NORTH SALT LAKE PLANNING COMMISSION
NOTICE & AGENDA
May 12, 2020
6:30 p.m.

MEMORANDUM

SUBJECT: Site Plan for an Electronic Shopping & Mail Order House, NSL GB Distribution Facility at 989 West Center Street

OVERALL SITE PLAN

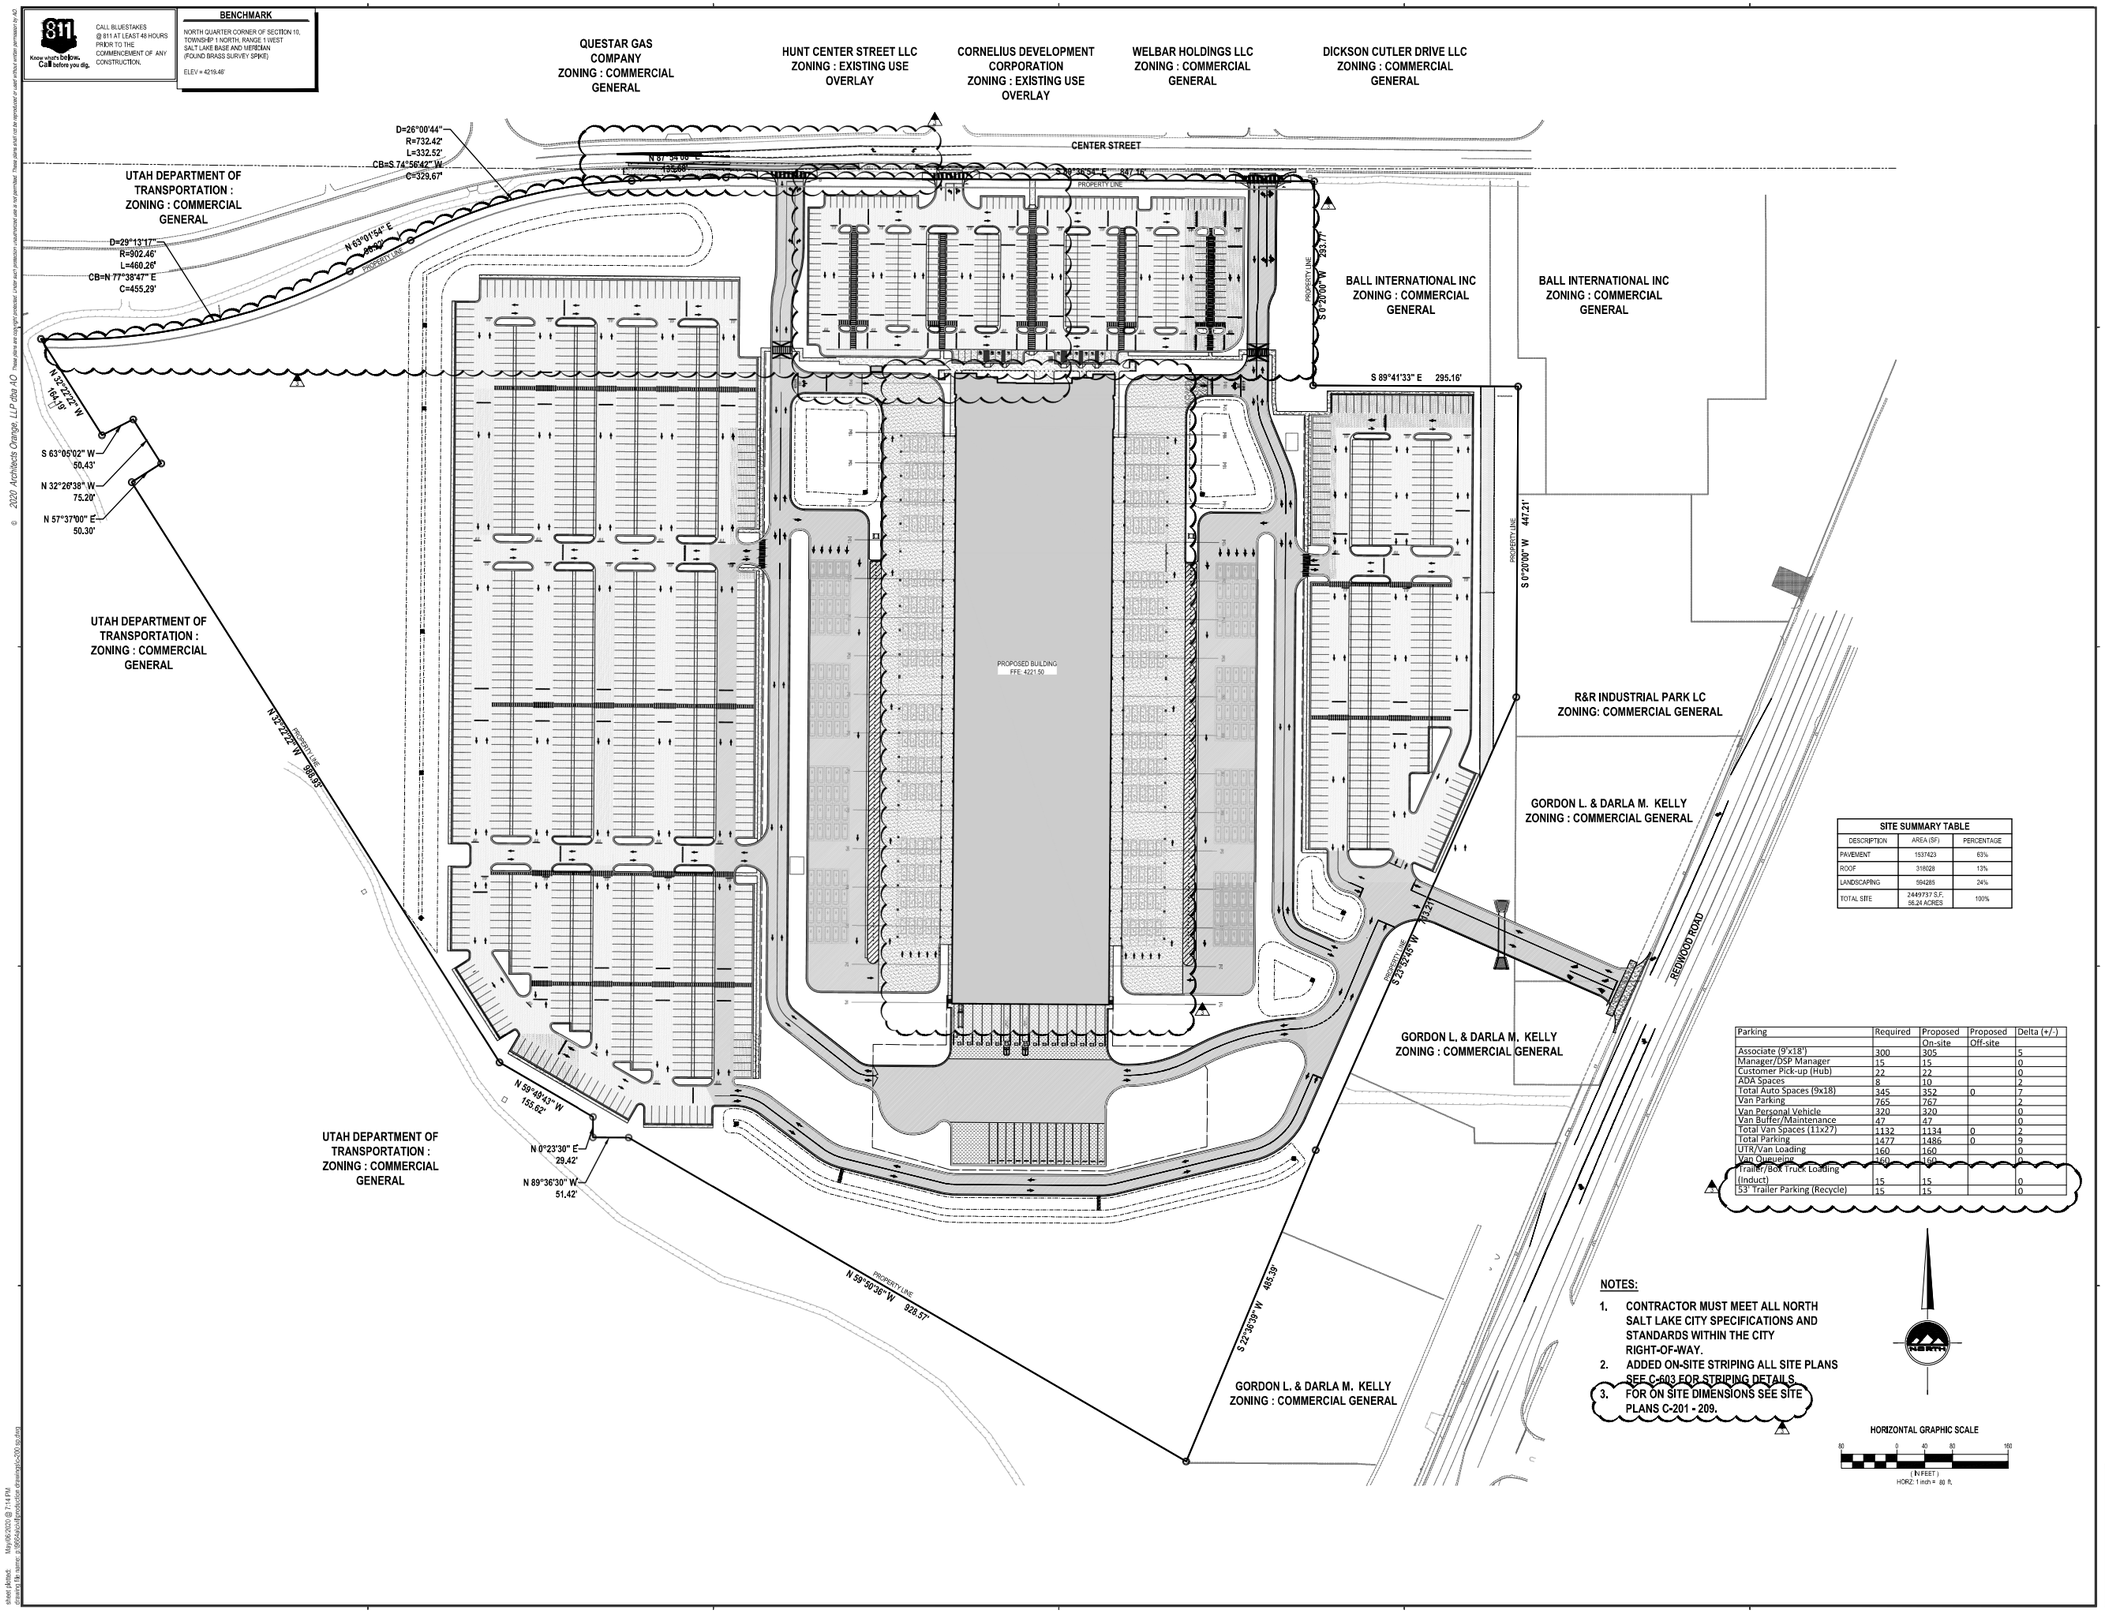
The building will have primary access from Center Street for employee parking and for delivery van deployment. All large truck deliveries will be made per the secondary access from Redwood Road that will be shared with the Kimball Retail Development. The second access will be located at the midpoint between the traffic signals at Center Street and the I-215 interchange. This intersection may be eligible for a traffic signal after the retail along Redwood Road is completed. The access will be a private access and will require the removal of the buildings located on what was previously the Kelly property, but recently acquired by the Kimball developers. A copy of the recorded ingress/egress agreement with the Kimballs will be required for this project. As part of this project, the new intersection will require the placement of a city owned street light, per the adopted standards and specifications for Redwood Road.

Ample on-site parking is being provided for both the employees and the delivery van area. The parking provided exceeds the minimum requirements for the office space and warehouse uses. Pedestrian access has been provided within the parking areas that are greater than 75,000 sq. ft. as required by the code. The parking on site is provided in the following manner:

The developer has agreed to dedicate to the city and additional 12’ of right of way along Center Street for any future widening necessary. One small section of Center Street will be widened at this time to accommodate a center turn lane into the western most entrance. This will also require a small section of the trail to be relocated a few feet south of the new curb. The city engineer has received a traffic study which

The applicant has submitted corrected drawings in response to staff redlines. The planning redlines have been satisfied. The city engineer will need to verify that his redlines have been satisfied. The building is greater than 30,000 sq. ft. in size and therefore the final site plan approval is reserved for the City Council with recommendation from the Planning Commission.

1. A street light will be required at the new intersection with Redwood Road per the newly adopted Redwood Road Street Light Standard;
2. Recordation of an ingress/egress agreement for this property across the Kimball property to Redwood Road; and
3. Verification of completion of engineering redlines.

PLANTING PLAN

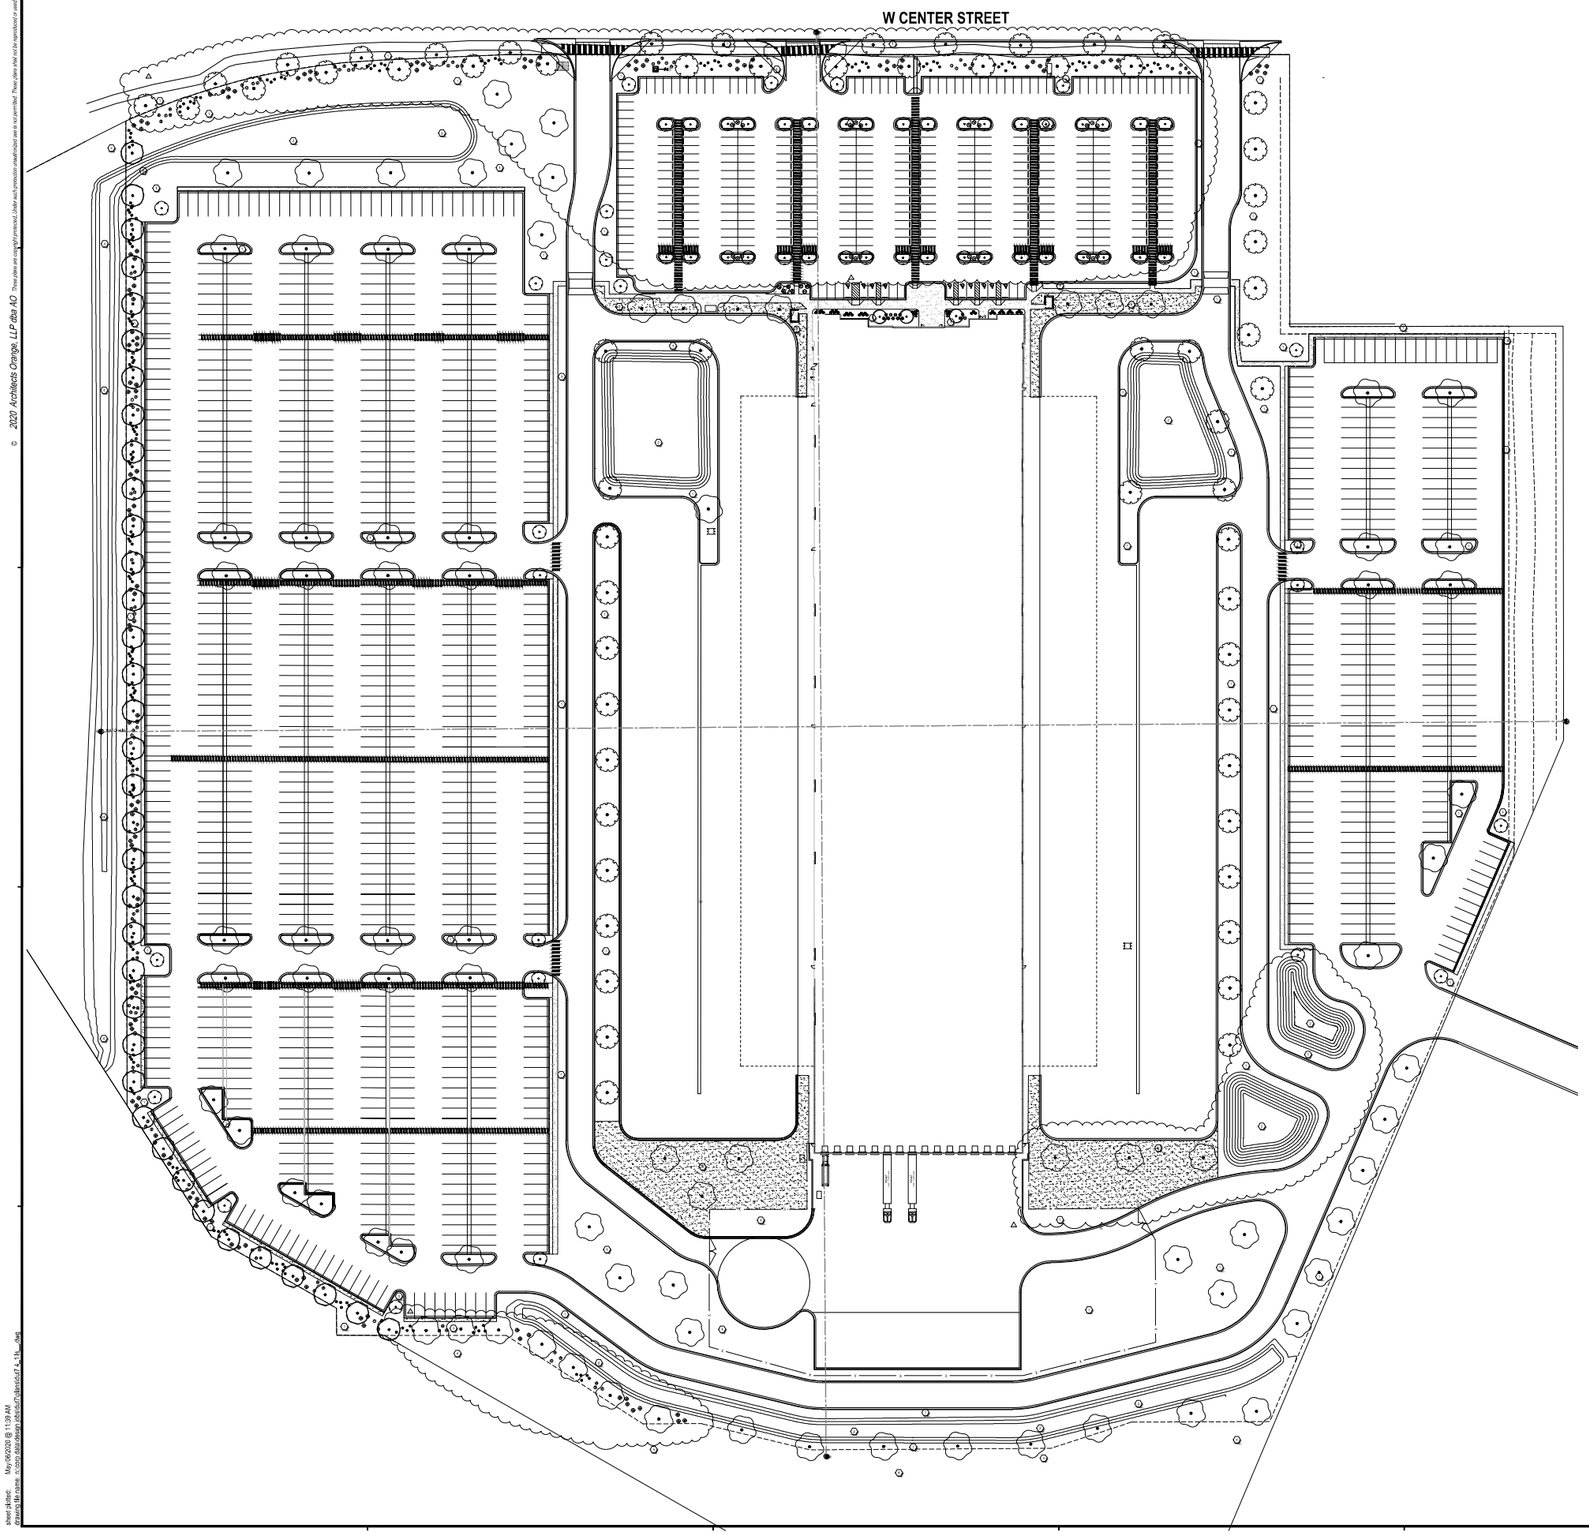
The landscape plan submitted shows an extensive landscape plan that includes 40,500 sq. ft. of turf area and 410,150 sq. ft. of planter areas with native grasses, planted shrubs, rock mulch and 248 trees. This equates to 10.35 acres, or approximately 18% of the site. An additional 3.3 acres will remain in native vegetation. Tree buffers and landscaped berms are to be planted along the western property lines to buffer the van parking areas from view of the Legacy Trail. Parking lot trees are included internal to the parking areas as well, with the exception of the van parking areas where the required islands for every 20 spaces has been waived in favor of additional perimeter trees. Additional trees and manicured landscaping along Center Street are shown far exceeding the minimum required. The total trees to be planted on the site is 248.

OVERALL EXTERIOR ELEVATION

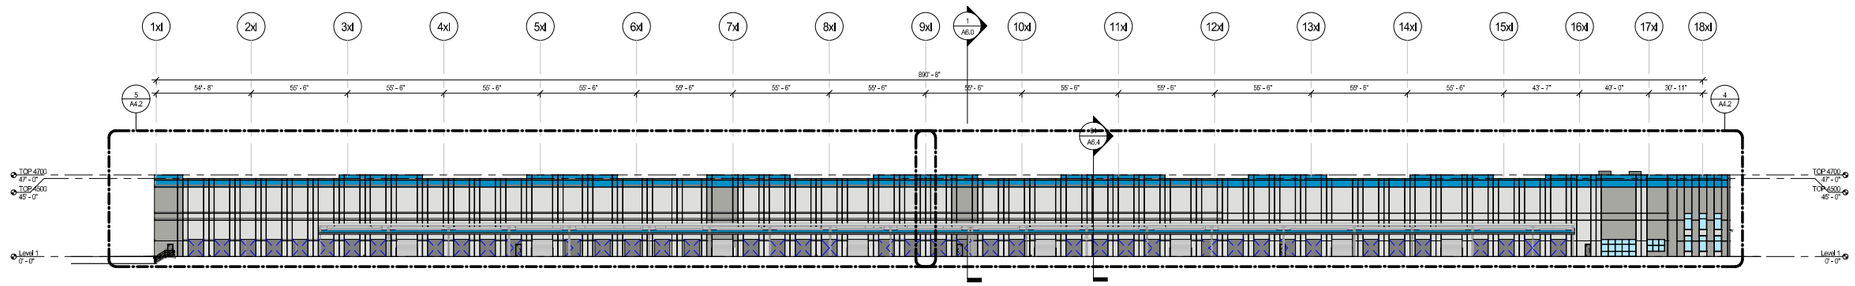
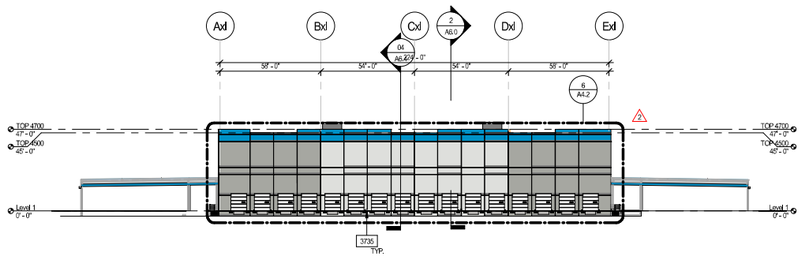
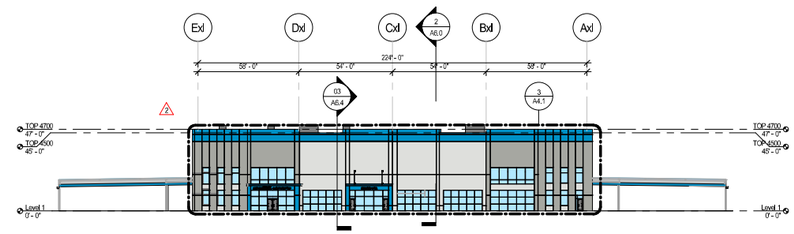
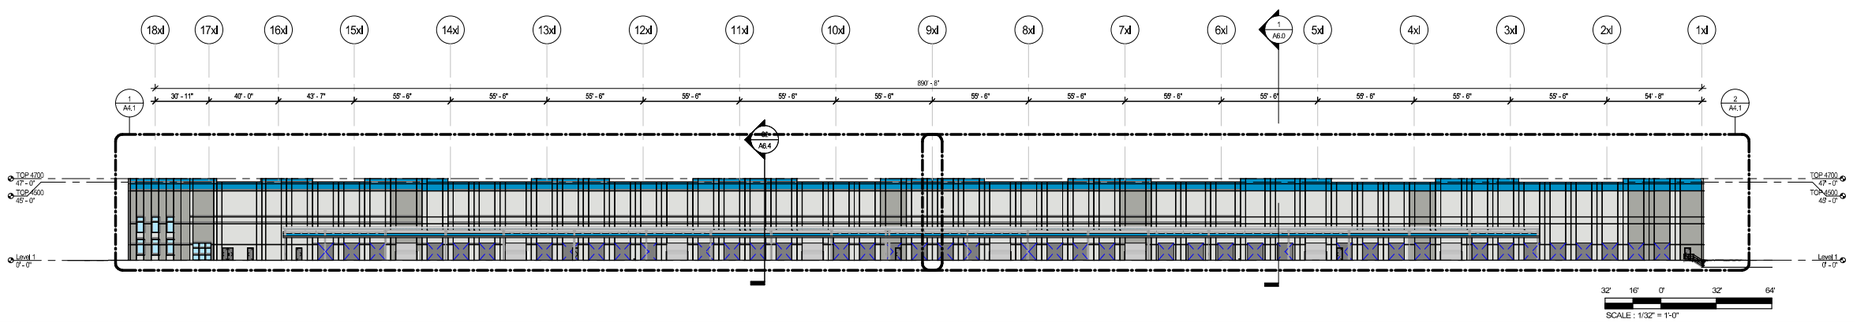
- Horizontal Articulation every 100 feet-*Each facade greater than one hundred feet (100') in length, measured horizontally, shall incorporate architectural features such as wall plane projections, recesses, or other building material treatments, colors and textures that visually interrupt the wall plane. No uninterrupted length of a facade may exceed one hundred (100) horizontal feet.*

(meets standard)
- Vertical Articulation every 30 feet in height-*max height 30 feet*

(meets standard)
- *Parapet Variation every 60 linear feet-All facades visible from a public right of way shall include a parapet that varies in height by at least two feet (2') for each sixty (60) linear feet of facade length.*

(meets standard)
- *Primary Building Entrance: Any primary entrance shall be clearly defined by either recessing the entrance or with a sheltering element such as an awning, arcade, or portico to provide shelter from the sun and inclement weather.*

- High quality materials-factory finished, integrally colored, or otherwise suitably treated-*brick construction (meets standard)*
- Metal siding, or materials which appear to be metal siding, prohibited except as accents (20%)-*(meets standard)*
- Metal roofs & doors permitted *(meets standard)*

The building design is tilt up concrete construction. The design incorporates recesses, color changes, and parapet variations as required by the design standards of the code. The building is 46 feet in height, under the maximum height limit of 60 feet. The west and east sides of the building have lean to structures to provide coverage from the weather for the purpose of loading the delivery vans. The south side of the building will be used exclusively for delivery via semi-trucks.
